6-2-2025

Reserves at Cobalt Circle – JGR Proj. 24-3446

ADDENDUM NO. 1

DIVISION OF ENGINEERING
SITE PAVING PLAN
LOCATION: 1616 EAST JEFFERSON STREET
BROWNSVILLE, TN.

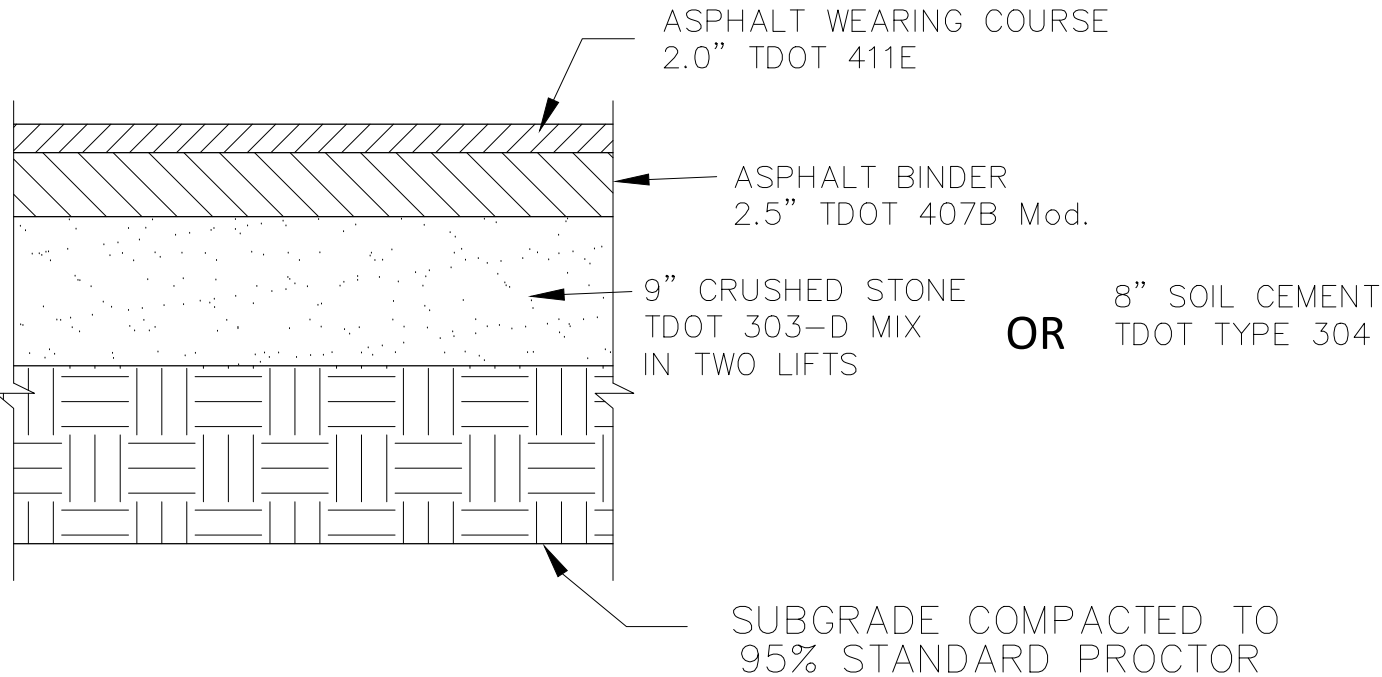
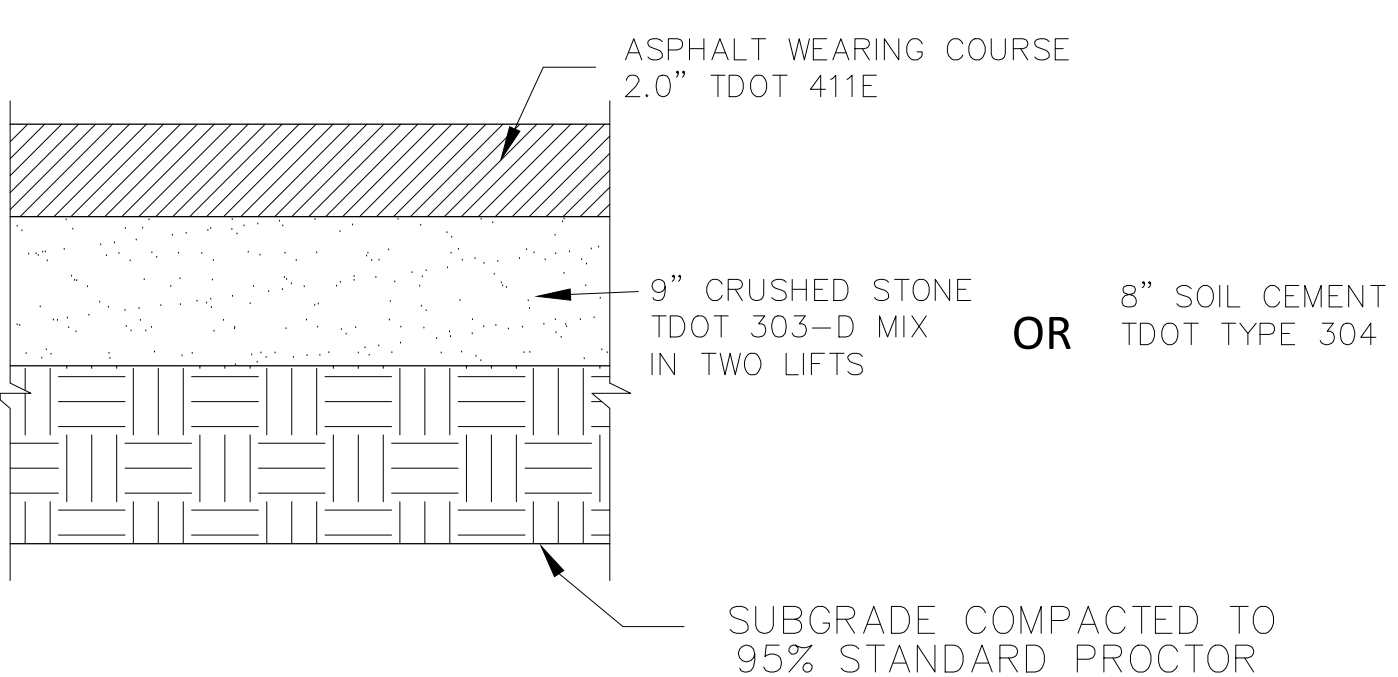
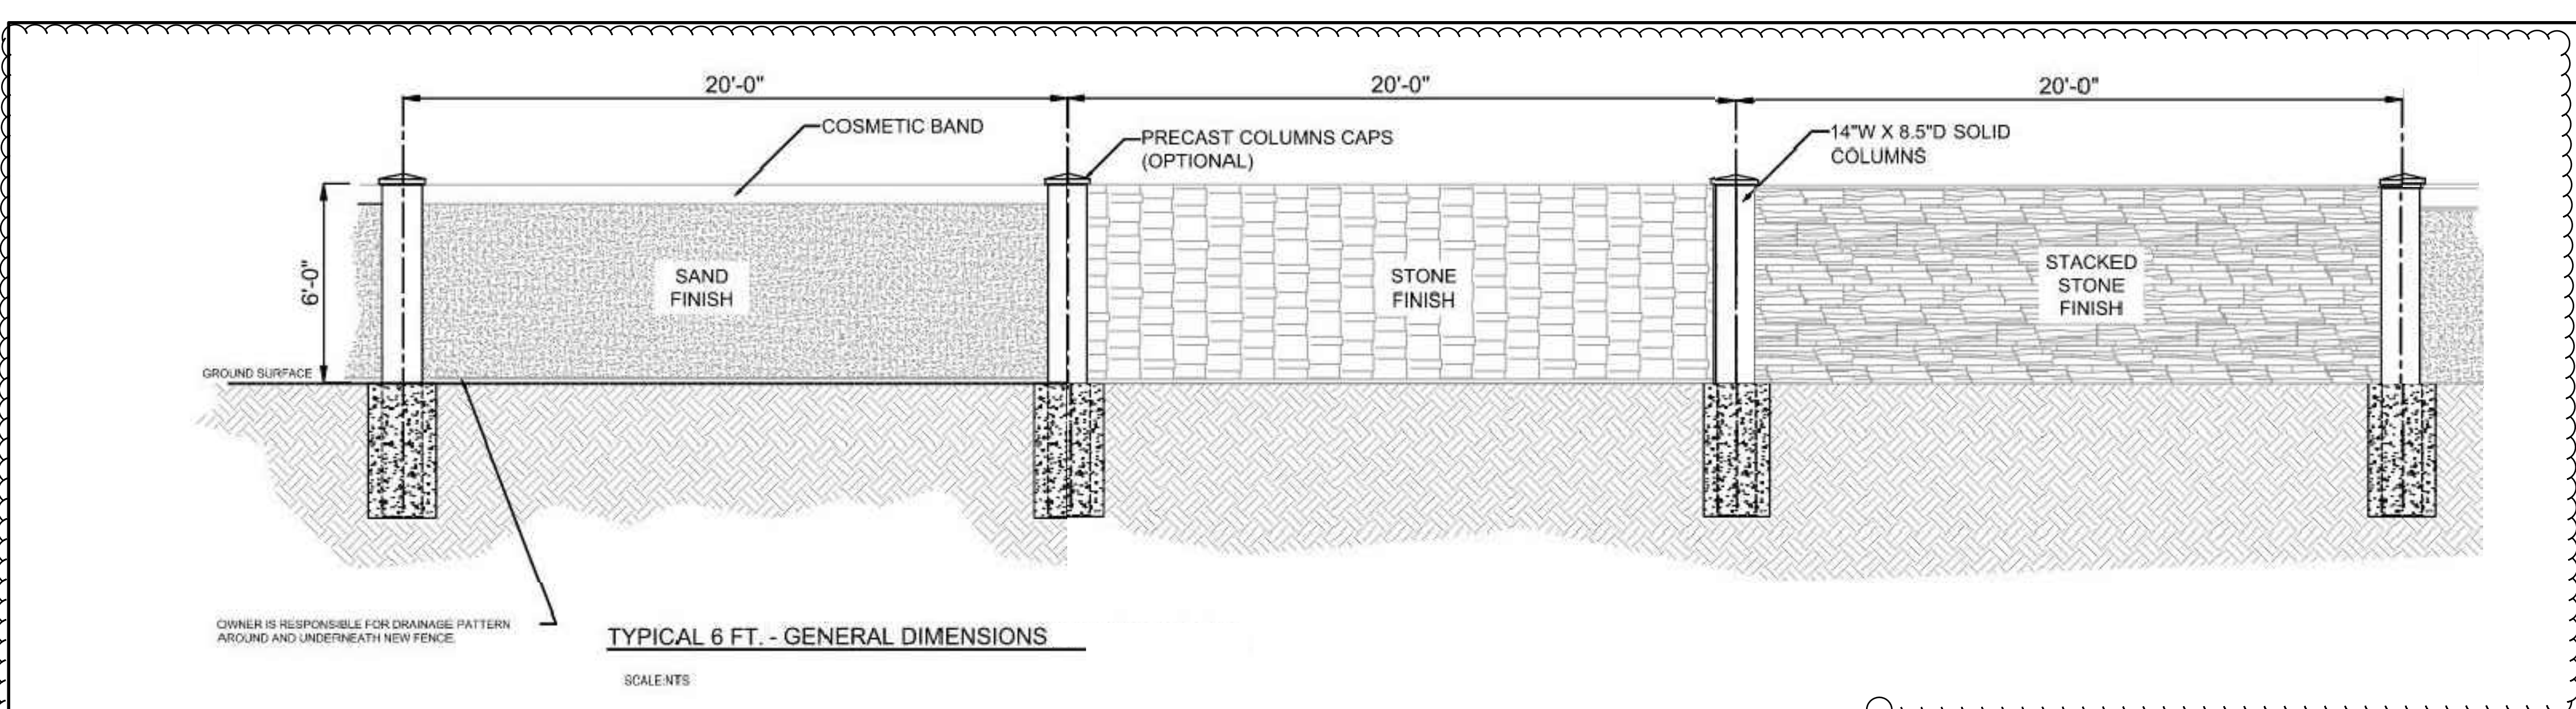
1. Site Plan Paving Sheet has been issued and added to the Full Civil Set. It will replace the Vehicle Turning Exhibit Sheet.
2. Site Details Sheet – Details on the Pre-Manufactured Wall have been added.

A SITE PLAN
1/32" = 1'-0"

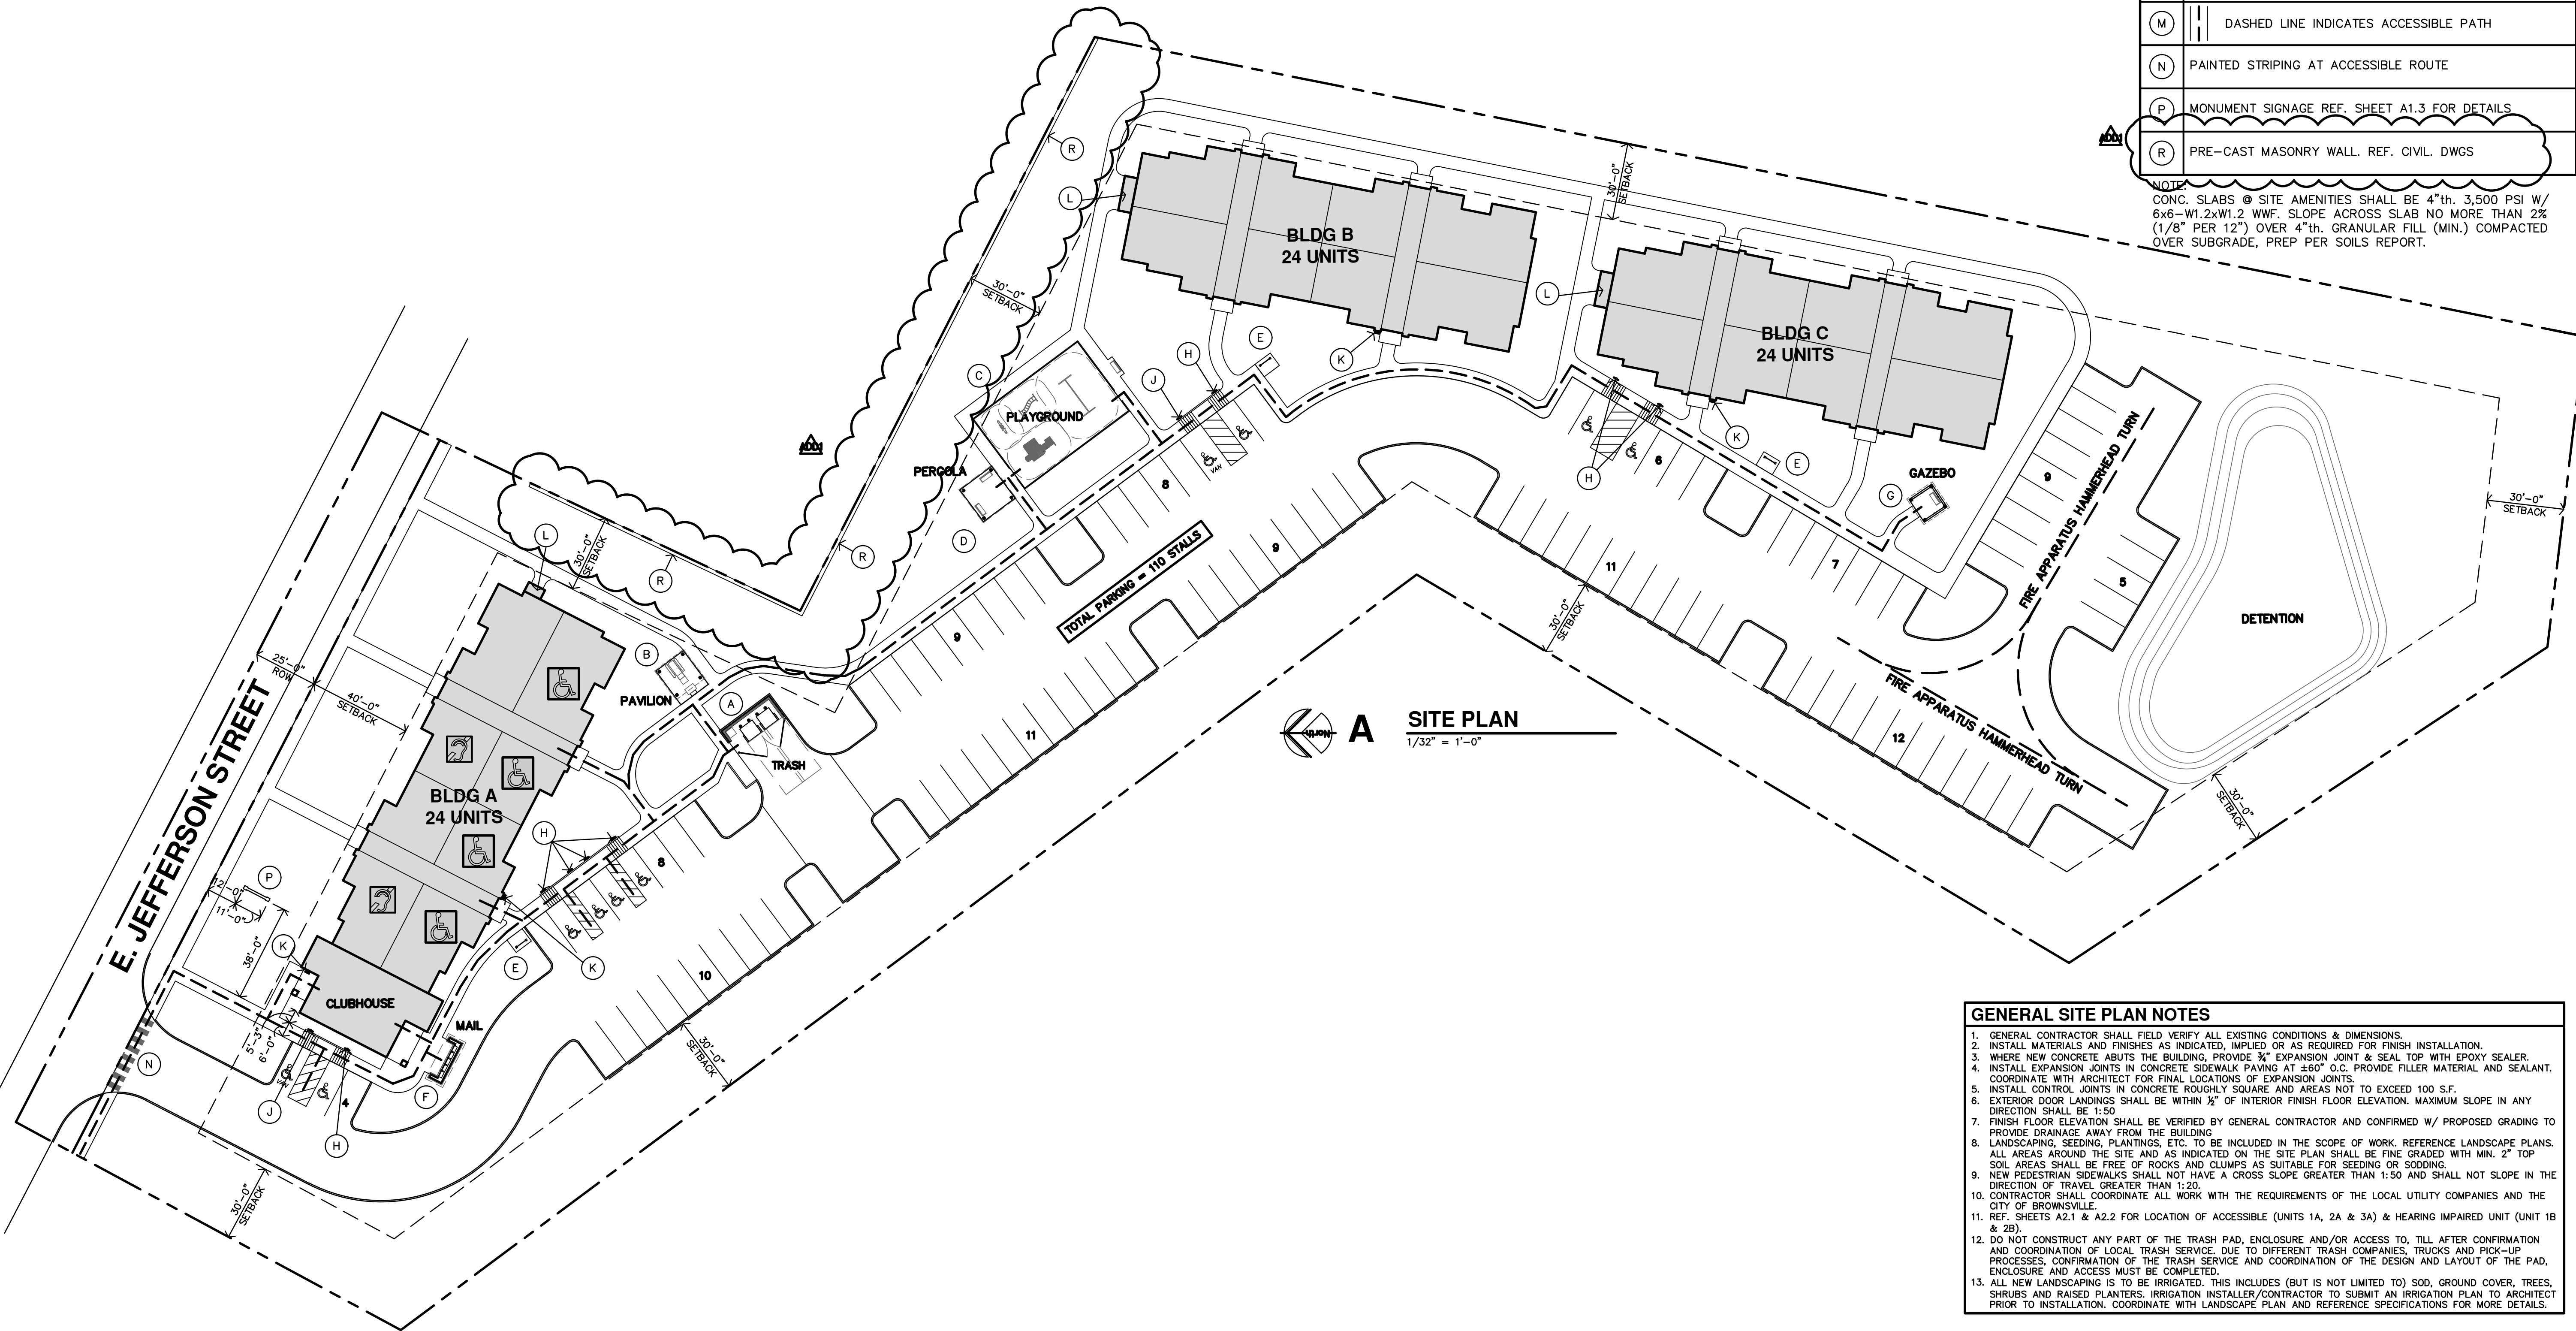
3. Cover Sheet has been updated to include Irrigation Plans and the Site Paving Plan.
4. A1.1 Site Plan – Pre-cast Masonry wall locations and Note 'R' has been added. Playground equipment has been modified.
5. A1.2 Site Equipment – Playground Equipment has been modified.
6. A2.3 1-Bedroom Unit Plans – Door type labels have been added to the plans.
7. A2.4 2-Bedroom Unit Plans – Door type labels have been added to the plans.
8. A2.5 Apartment Door Schedule – Door #7 has been added. Notes & door type on Door #6 have been modified. Door type 'C' has been added.
9. A2.11 Clubhouse Floor Plan – Built-in Kitchen Island with cabinets and countertop has been eliminated. Owner to provide furnishing for this area.
10. A2.12 Clubhouse Details – Details B, C & D are no longer applicable. Kitchen island has been eliminated.
